How to distinguish WI-PS306GF-UPS-15A versions

WI-PS306GF-UPS-15A Version Update Log

OptionA:Distinguish by appearance

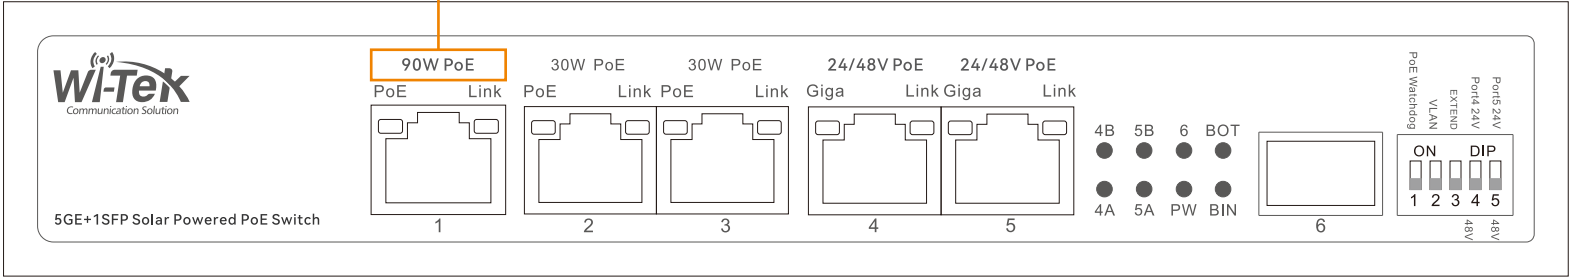
Hardware Version	Software Version	Different	Describe
V2	V1.34	    Phoenix Connector Mark LED Indicators DIP Switch Mark RS-485 90W PoE for port 1 	1, NEW DIP switch mark for NEW software 2, There is RS-485 terminal. 3, There is no grounding terminal. 4, Phenix connector mark is “S1+, S1-, S2+, S2-, B-, B+”. 5, LED indicator is “BS”. 6, 90W PoE for port 1.
V2	V1.30	   Phoenix Connector Mark LED Indicators RS-485	1, There is RS-485 terminal. 2, There is no grounding terminal. 3, phenix connector mark is “S1+, S1-, S2+, S2-, B-, B+”. 4, LED indicator is “BS”.
V1	/	   Phoenix Connector Mark LED Indicator Grounding	1, There is grounding terminal. 2, Phenix connector mark is “S+, S-, V+, V-, B-, B+”. 3, LED indicator is “VIN”.
